STAFF REPORT ADDENDUM

APPLICATION RZ/FDP 2011-MA-029

APPLICANT: Neighborhoods VI, LLC

PROPOSAL: The applicant seeks to rezone 8.79 acres from R-2 and HC (Highway Corridor Overlay) to PDH-4 (Planned Development at 4 du/ac) and HC to permit the development of 29 single family detached dwelling units at an overall density of 3.30 du/ac.

CONCEPTUAL/FINAL DEVELOPMENT PLAN
EXTENT OF REVIEW AND OUTFALL NARRATIVE
CALLAWAY

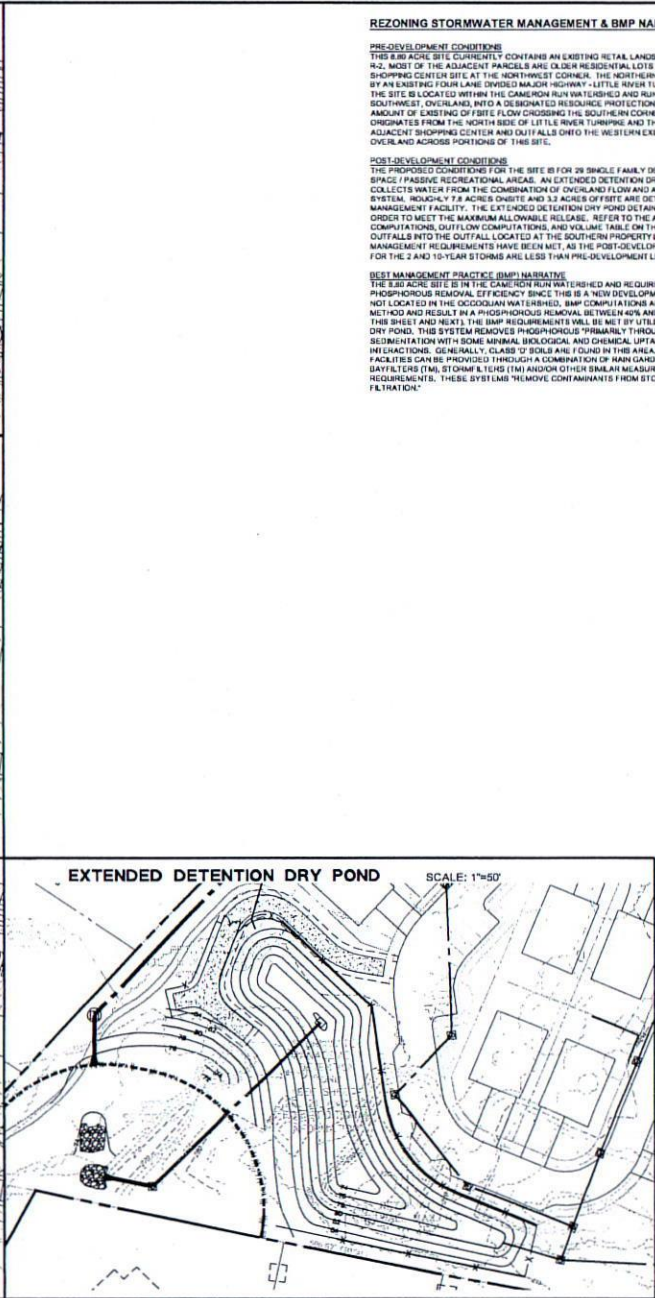
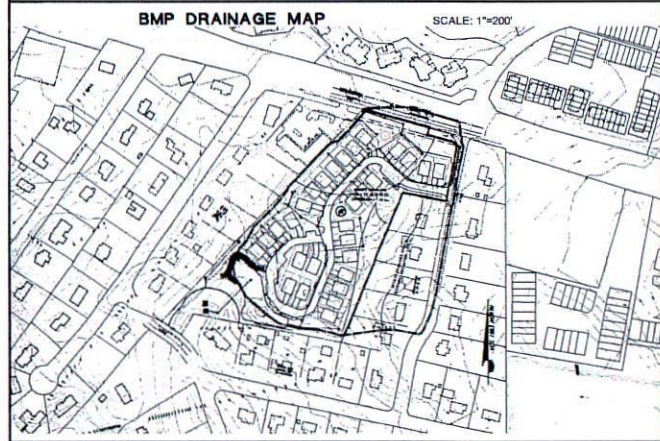
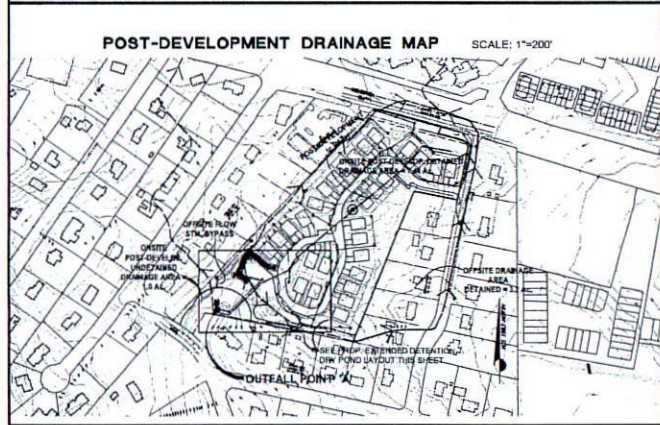
The current drawings show the storm drain system discharging to the pond with pipes constructed underneath a retaining wall (Sheet 21). Construction plans showing this alignment will not be approvable (PFM 6-0902.2I).
